ACCESSIBILITY ASSESSMENT

165715.24R000-001.303

ADA TITLE II ASSESSMENT

Abernethy Annex

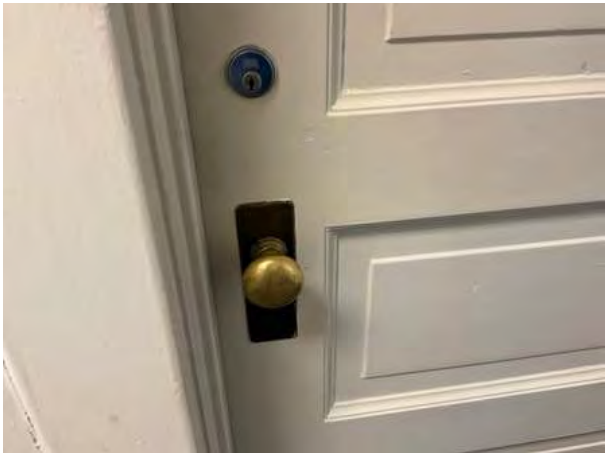
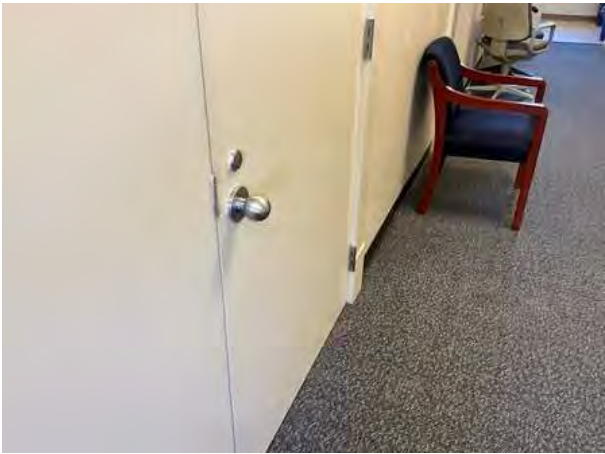
The hardware at the accessible door (including sliding doors - both sides) requires tight grasping, pinching or twisting of the wrist to operate OR is mounted below 34" or above 48".

18 doors have ball style door handles, that require tight grasping and twisting of the wrist to operate.

Remove hardware and replace with hardware that has a shape that is easy to grasp such as lever, push-type or U-shaped handles. Handles, pulls, latches, locks, and other operable parts on doors and gates shall be compliant. Operable parts of such hardware shall be 34" minimum and 48" maximum above the finish floor or ground. Where sliding doors are in the fully open position, operating hardware shall be exposed and usable from both sides. [EXCEPTIONS: 1. Existing locks shall be permitted in any location at existing glazed doors without stiles, existing overhead rolling doors or grilles, and similar existing doors or grilles that are designed with locks that are activated only at the top or bottom rail. 2. Access gates in barrier walls and fences protecting pools, spas, and hot tubs shall be permitted to have operable parts of the release of latch on self-latching devices at 54" maximum above the finish floor or ground provided the self-latching devices are not also self-locking devices and operated by means of a key, electronic opener, or integral combination lock.]

Map for Barrier ID: AX455970

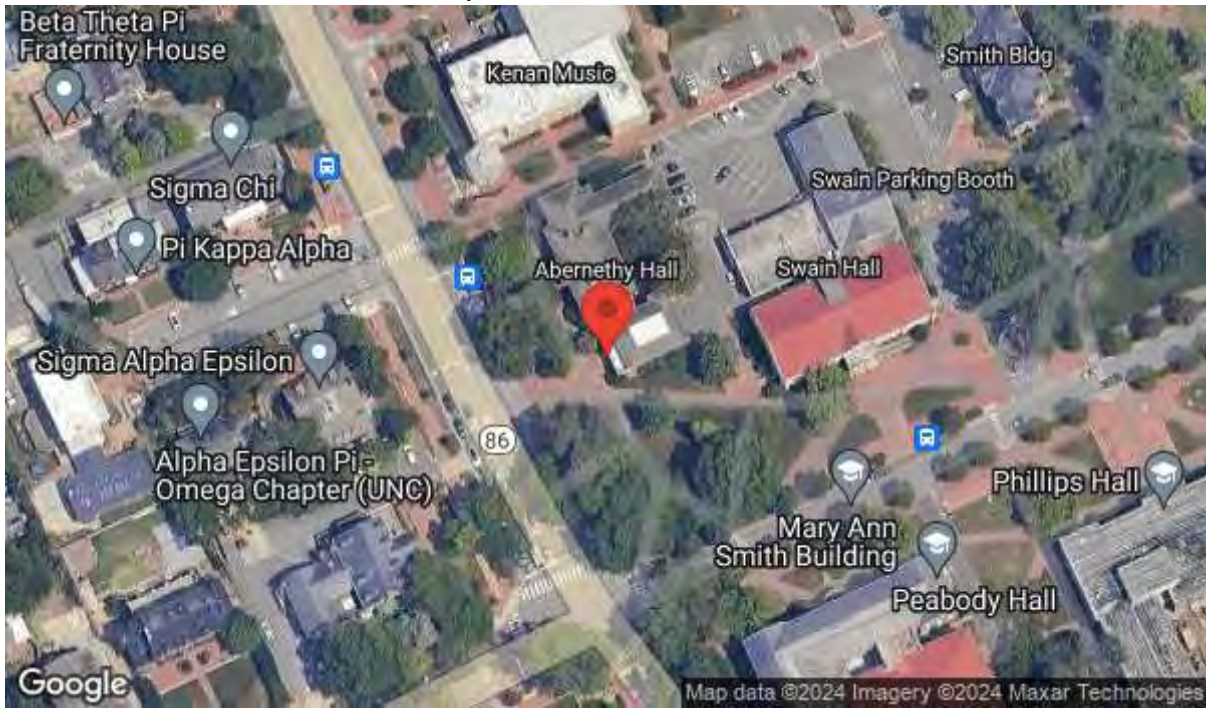
Assembly	Exterior Access Route
Type	Stairs
ADA Standard	505
Barrier Detail	Handrails are not compliant or are not provided.
Location Description	Front entry
Observed	May 22, 2024 by Brian.rogers@bureauveritas.com
Site Conditions	The handrails provided do not extend the entire length of the stairs

Install handrails on both sides of all stairs that comply with guidelines. Handrails shall be provided on both sides of stairs. Handrails shall be continuous within the full length of each stair flight or ramp run. Inside handrails on switchback or dogleg stairs and ramps shall be continuous between flights or runs. Top of gripping surfaces of handrails shall be 34" minimum and 38" maximum vertically above walking surfaces, stair nosings, and ramp surfaces. Handrails shall be at a consistent height above walking surfaces, stair nosings, and ramp surfaces. Clearance between handrail gripping surfaces and adjacent surfaces shall be 1-1/2" minimum. Handrail gripping surfaces shall be continuous along their length and shall not be obstructed along their tops or sides. The bottoms of handrail gripping surfaces shall not be obstructed for more than 20% of their length. Where provided, horizontal projections shall occur 1-1/2" minimum below the bottom of the handrail gripping surface.

Photos for Barrier ID: AX455991

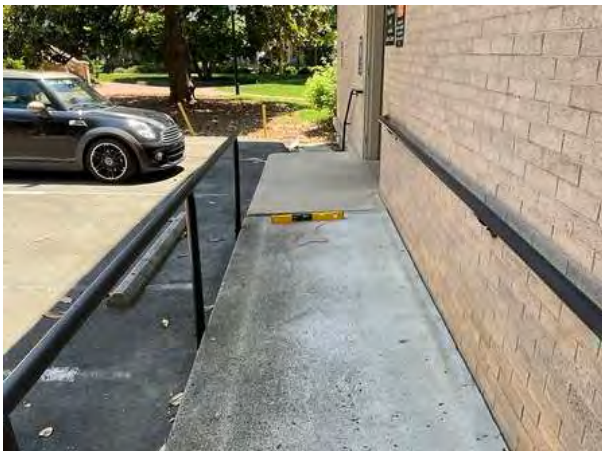
Barrier Detail	The ramp has cross slopes in excess of 1:48 (2.08%).
----------------	--

The top portion of the ramp has cross slopes between 3.1% and 3.4% for a length of 16 feet.

The ramp should be removed and an accessible ramp should be installed. Ramp runs shall have a cross slope not steeper than 1:48. Ramp runs shall have a running slope not steeper than 1:12. [EXCEPTION: In existing sites, buildings, and facilities built pre 1/26/92, ramps shall be permitted to have running slopes steeper than 1:12 where such slopes are necessary due to space limitations. Where slopes are steeper than 1:10 but not steeper than 1:8, the rise shall be 3" maximum. Where slopes are steeper than 1:12 but not steeper than 1:10, the rise shall be 6" maximum.]

Photos for Barrier ID: AX455994

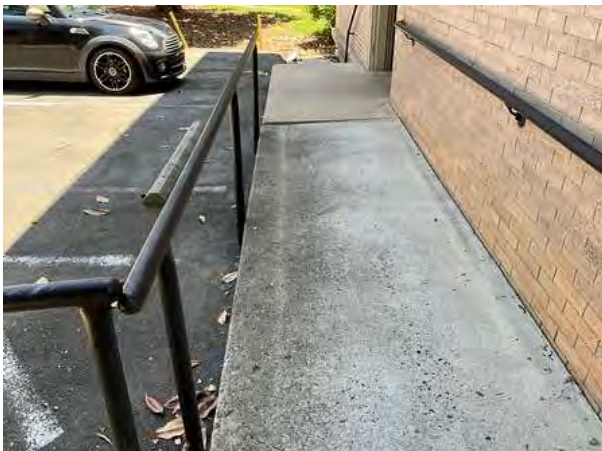
Assembly	Exterior Access Route
Type	Ramp
ADA Standard	505.6
Barrier Detail	The handrail height is not compliant.
Location Description	Rear Entrance
Observed	May 22, 2024 by Brian.rogers@bureauveritas.com

The handrail Heights are 31 and 33 inches above the ramp surface for 54 linear feet.

The top of the gripping surface of the handrail shall be 34" minimum and 38" maximum vertical above ramp surfaces. Remove this barrier in conjunction with Barrier ID 455994. Handrails shall be at a consistent height above ramp surfaces. Provide compliant handrails on both sides of the ramp. The handrails on each side shall be a minimum 36" apart horizontally. The top of the gripping surface of the handrail shall be 34" minimum and 38" maximum vertical above ramp surfaces. Handrails shall be at a consistent height above ramp surfaces. The gripping surface of handrails shall be 1.25" to 2" diameter, or a non-circular grip that has a perimeter dimension of 4" to 6.25" maximum. Handrails shall be provided on both sides of ramps. Provide a bottom rail that is maximum 4" from the ramp surface and prevents the passage of a 4" diameter sphere between the ramp surface and the rail.

Photos for Barrier ID: AX455989

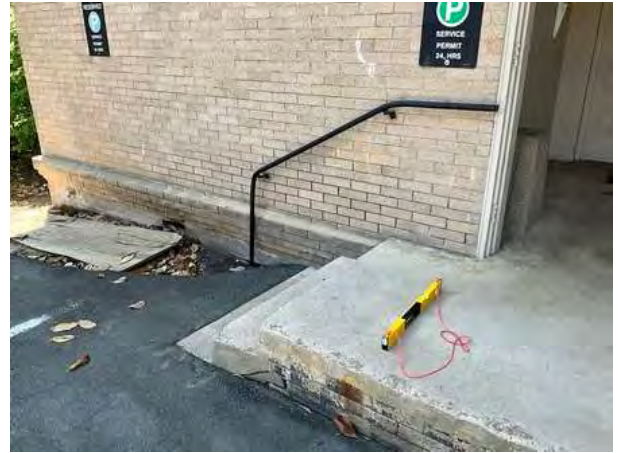
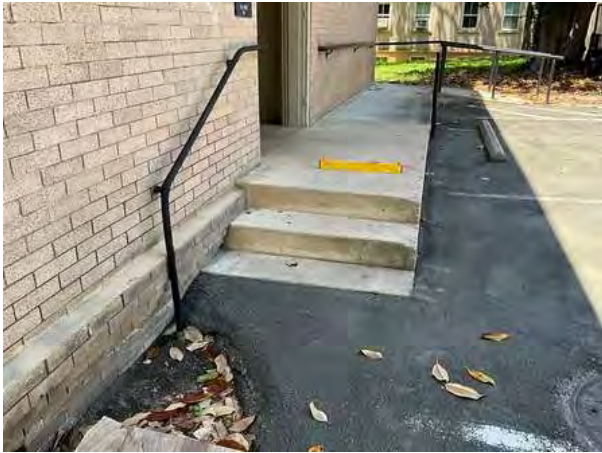
Assembly	Exterior Access Route
Type	Stairs
ADA Standard	505
Barrier Detail	Handrails are not compliant or are not provided.
Location Description	Rear Entrance
Observed	May 22, 2024 by Brian.rogers@bureauveritas.com
Site Conditions	A handrail is missing on the outside of the steps.

Install handrails on both sides of all stairs that comply with guidelines. Handrails shall be provided on both sides of stairs. Handrails shall be continuous within the full length of each stair flight or ramp run. Inside handrails on switchback or dogleg stairs and ramps shall be continuous between flights or runs. Top of gripping surfaces of handrails shall be 34" minimum and 38" maximum vertically above walking surfaces, stair nosings, and ramp surfaces. Handrails shall be at a consistent height above walking surfaces, stair nosings, and ramp surfaces. Clearance between handrail gripping surfaces and adjacent surfaces shall be 1-1/2" minimum. Handrail gripping surfaces shall be continuous along their length and shall not be obstructed along their tops or sides. The bottoms of handrail gripping surfaces shall not be obstructed for more than 20% of their length. Where provided, horizontal projections shall occur 1-1/2" minimum below the bottom of the handrail gripping surface. [EXCEPTIONS: 1. Where handrails are provided along walking surfaces with slopes not steeper than 1:20, the bottoms of handrail gripping surfaces shall be permitted to be obstructed along their entire length where they are integral to crash rails or bumper guards. 2. The distance between horizontal projections and the bottom of the gripping surface shall be permitted to be reduced by 1/8" for each 1/2" of additional handrail perimeter dimension that exceeds 4".] Handrail gripping surfaces with a circular cross section shall have an outside diameter of 1-1/4" minimum and 2" maximum. Handrail gripping surfaces with a non-circular cross section shall have a perimeter dimension of 4" minimum and 6-1/4" maximum, and a cross-section dimension of 2-1/4" maximum. Handrail gripping surfaces and any surfaces adjacent to them shall be free of sharp or abrasive elements and shall have rounded edges. Handrails shall not rotate within their fittings. Handrail gripping surfaces shall extend beyond and in the same direction of stair flights. At the top of a stair flight, handrails shall extend horizontally above the landing for 12" minimum beginning directly above the first riser nosing. At the bottom of a stair flight, handrails shall extend at the slope of the stair flight for a horizontal distance at least equal to one tread depth beyond the last riser nosing. Extensions shall return to a wall, guard, or the landing surface, or shall be continuous to the handrail of an adjacent stair flight. [EXCEPTIONS: 1. Extensions shall not be required for continuous handrails at the inside turn of switchback or dogleg stairs and ramps AND 3. In alterations, full extensions of handrails shall not be required where such extensions would be hazardous due to plan configuration.] [ADVISORY: It is advisable, but not required, to provide a handrail at a height designed for children. When children are the principal users in a building or facility (e.g., elementary schools), a second set of handrails at an appropriate height can assist them and aid in preventing accidents. A maximum height of 28" measured to the top of the gripping surface from the ramp surface or stair nosing is recommended for handrails designed for children. Sufficient vertical clearance between upper and lower handrails, 9" minimum, should be provided to help prevent entrapment.]

Photos for Barrier ID: AX455990

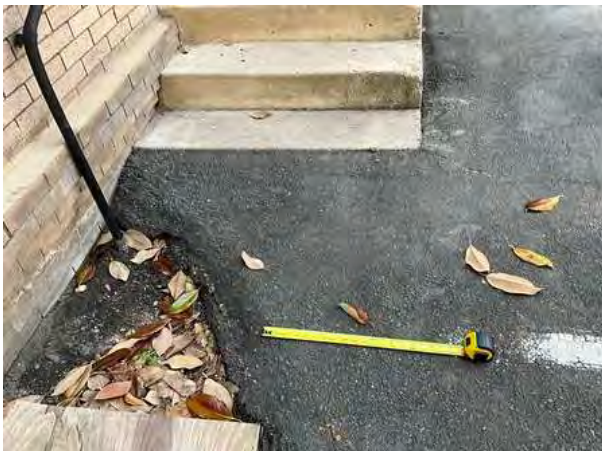
Assembly	Exterior Access Route	
Type	Stairs	
ADA Standard	403.5.1; 403.5.3	
Barrier Detail		
Sidewalk does not meet the 36" minimum clear width requirement (60" minimum where passing areas are present).		
Location Description	Rear Entrance	
Observed	May 22, 2024 by Brian.rogers@bureauveritas.com	
Site Conditions		
The landing has been cut out at the bottom of the steps is only 18 inches wide.		
Width	18"	
Resolution		
The sidewalk should be removed and replaced with a compliant sidewalk. The clear width of walking surfaces shall be 36" minimum. [EXCEPTION: The clear width shall be permitted to be reduced to 32" minimum for a length of 24" maximum provided that reduced width segments are separated by segments that are 48" long minimum and 36" wide minimum.] An accessible route has maximum 1:20 (5%) running slope and maximum 1:50 (2%) cross slope. [EXCEPTION: Cross slopes not greater than 1:48 (2.08%) are permitted.]

Photos for Barrier ID: AX455985

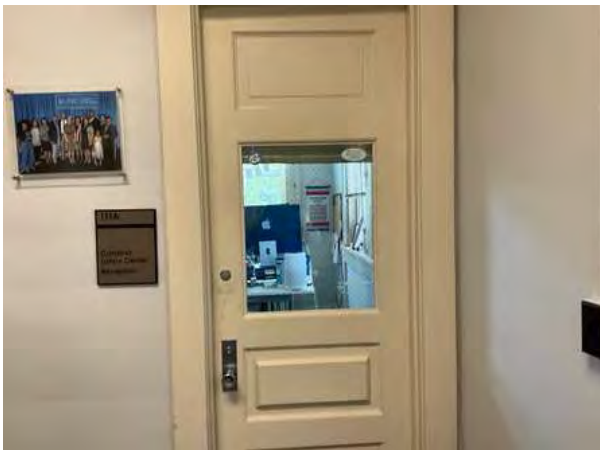
Assembly	Interior Access Route
Type	Door
ADA Standard	307.4, 404.2.3
Barrier Detail	The door has less than 32" clear width.
Location Description	Room 111A
Observed	May 22, 2024 by Brian.rogers@bureauveritas.com
Site Conditions	The door is 31 inches wide.
Width	31"

Remove and replace with a door that has a minimum clear opening of 32". Door openings shall provide a clear width of 32" minimum. Clear openings of doorways with swinging doors shall be measured between the face of the door and the stop, with the door open 90 degrees. Openings more than 24" deep shall provide a clear opening of 36" minimum. There shall be no projections into the required clear opening width lower than 34" above the finish floor or ground. Projections into the clear opening width between 34" and 80" above the finish floor or ground shall not exceed 4". [EXCEPTIONS: 1. In alterations, a projection of 5/8" maximum into the required clear width shall be permitted for the latch side stop. 2. Door closers and door stops shall be permitted to be 78" minimum above the finish floor or ground.]
